MECKLENBURG COUNTY
GROUNDWATER & WASTEWATER SERVICES

APPLICATION FOR A RESIDENTIAL SITE IMPROVEMENT PERMIT/ CONSTRUCTION AUTHORIZATION FOR AN ON-SITE WASTEWATER SYSTEM, NEW WELL INSTALLATION, OR REPAIR OF EXISTING WELL

SOIL/SITE EVALUATION
for ON-SITE WASTEWATER SYSTEM

Re: Application for improvement permit for:
Property Site: 712 BRIDLEPATH TR
Health Department file number: **8056B**

Sketch of Soil Evaluation Locations

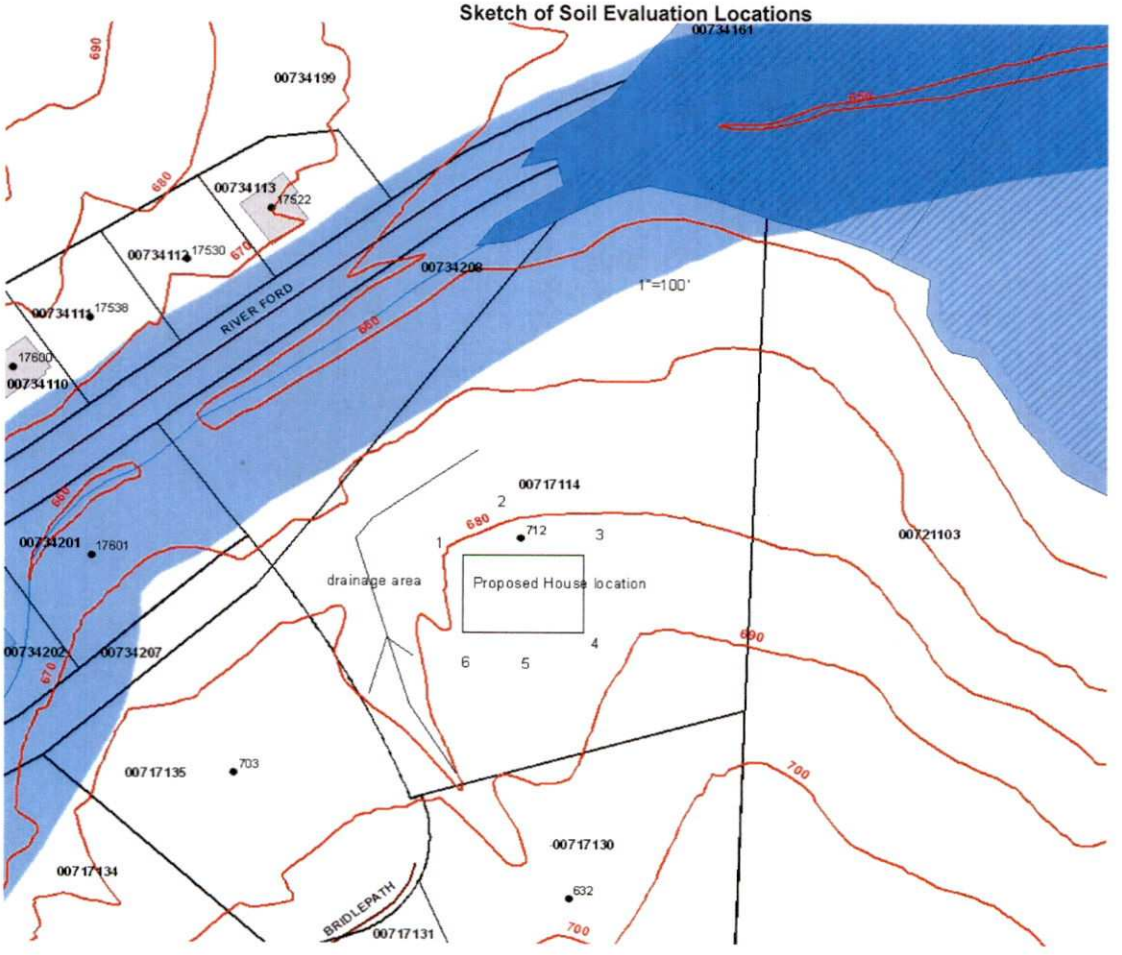
Other Factors (.1946):
Soil Evaluation By: Jason Jackson
Others Present: Bill Marlin
Site Classification (.1948): UNSUITABLE
Site Evaluation By:
Others Present:

COMMENTS:
100% repair area required

Sketch of Soil Evaluation Locations

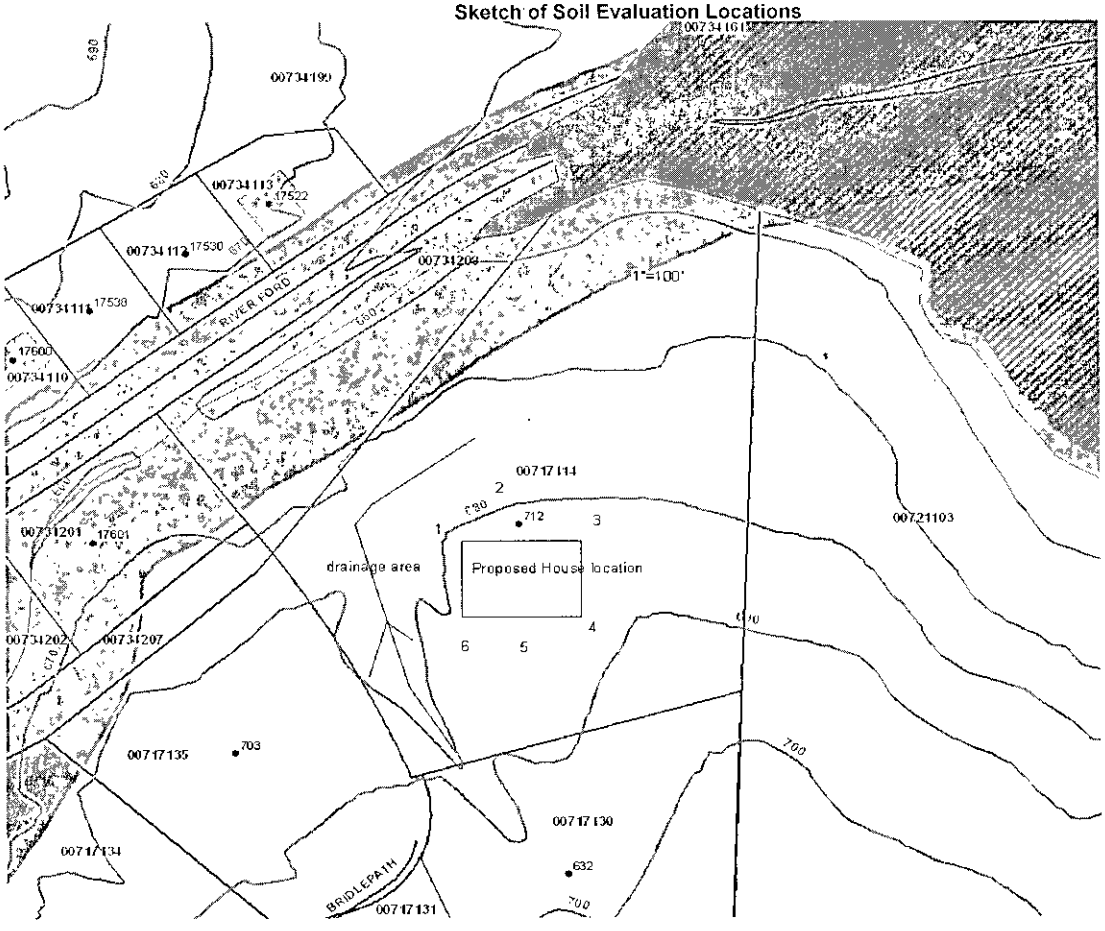
Other Factors (.1946):
Soil Evaluation By: Jason Jackson
Others Present: Bill Marlin
Site Classification (.1948): UNSUITABLE
Site Evaluation By:
Others Present:

100% repair area required

SOIL EVALUATION LOCATIONS FOR
712 Bridlepath Trail
APPLICATION # 4304

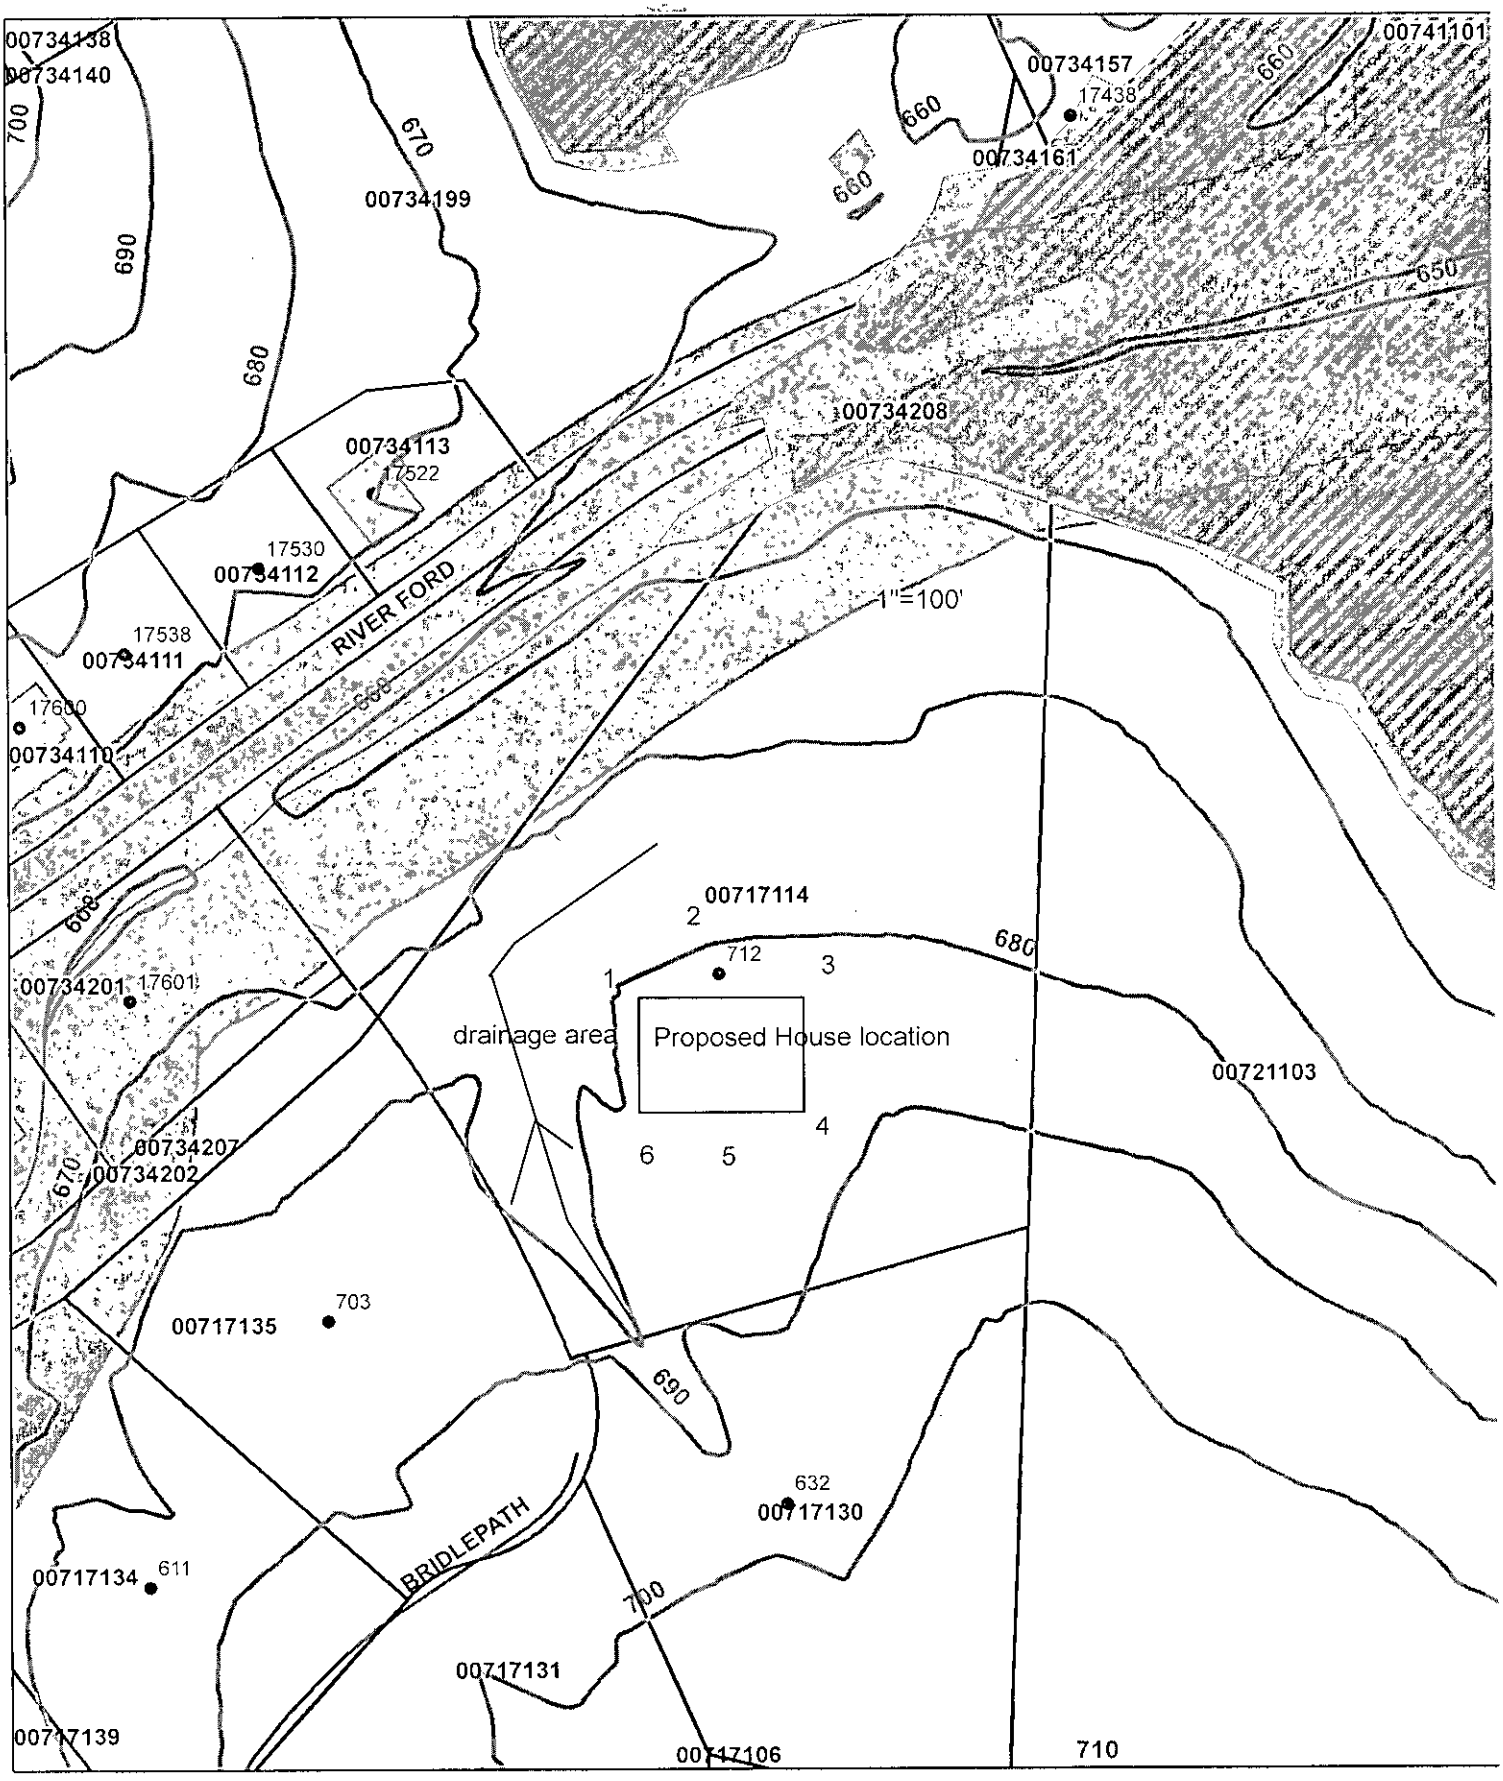
Based on the criteria set out in Title 15A, Subchapter 18A, of the North Carolina Administrative Code, Rules .1940 through .1948, the evaluation indicated that the site is **UNSUITABLE** for a ground absorption sewage system. Therefore, your request for an improvement permit is **DENIED.** A copy of the site evaluation is enclosed. The site is unsuitable based on the following:

- ☐ Unsuitable soil topography and/or landscape position (Rule .1940)
- ☒ Unsuitable soil characteristics (structure or clay mineralogy) (Rule .1941)
- ☒ Unsuitable soil wetness condition (Rule .1942)
- ☒ Unsuitable soil depth (Rule .1943)
- ☐ Presence of restrictive horizon (Rule .1944)
- ☐ Insufficient space for septic system and repair area (Rule .1945)
- ☐ Unsuitable for meeting required setbacks (Rule .1950)
- ☐ Other (Rule .1946)

These severe soil or site limitations could cause premature system failure, leading to the discharge of untreated sewage on the ground surface, into surface waters, directly to ground water or inside your structure.

The site evaluation included consideration of possible site modifications, and modified, innovative or alternative systems. However, the Health Department has determined that none of the above options will overcome the severe conditions on this site. A possible option might be a system designed to dispose of sewage to another area of suitable soil or off-site to additional property.

However, the site classified as **UNSUITABLE** may be classified as **PROVISIONALLY SUITABLE** if written documentation is provided that meets the requirements of Rule .1948(d). A copy of this rule is enclosed. You may hire a consultant to assist you if you wish to try to develop a plan under which your site could be reclassified as **PROVISIONALLY SUITABLE.**
